product information

Volume 10

December 2010

Jungle Gym Configuration Update

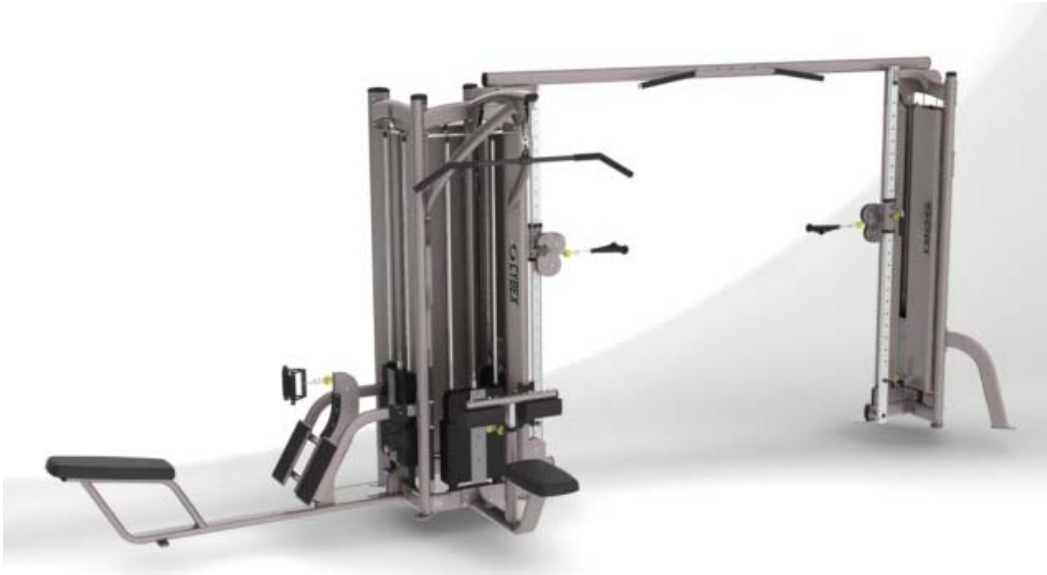
Beginning with January 3rd production the Jungle Gym will be configured as a “square” product. That is all four sides of the Quad Tower will have the same width. This allows for complete interchangeability of stations and will no longer have the limitation of placing light and heavy stations.

All stations will now use a mix of 10 and 15 lb plates. The former “heavy” stations now have revised product numbers to reflect their updated configurations.

In the new configuration, the Lat Pulls and Low Rows now have 255 lbs. (116 kg) weight stacks.

With the new configuration, only the previous 17007 Blank Panel is used when filling a blank position. Please also recall that when using blank panels two rules still apply:

1. *If a tandem is to be created, the stations must be directly across from each other and not adjacent. This will require the use of two Blank Panels.*
2. *Under **no** circumstance can three blank panels be used to create a “free standing” “single station” unit.*
